Addendum

LAND AT DUCKS NEST, ARBORFIELD, EVERSLEY ROAD (250733)

March 2026

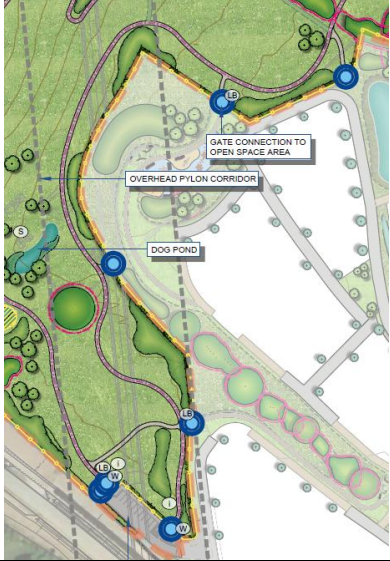
2.11	The plan does not make clear what fencing will be in place around the site. In order to secure the site for potential livestock in future management and for dogs, stock-proof fencing should be present and in good order around the entire site boundary. Detail should be provided on the fencing to be used on the entire site boundary. With this in mind, there is also no proposed detail on gates or access from the PROW in the northwest corner of the site. Further detail should be given on how the site will be secured in this corner and how access will be retained to the PROW.	Stockproof fencing is now shown around the whole site, and as requested by the Ecology officer 2 x badger gates have been included to provide access to the land to the north.
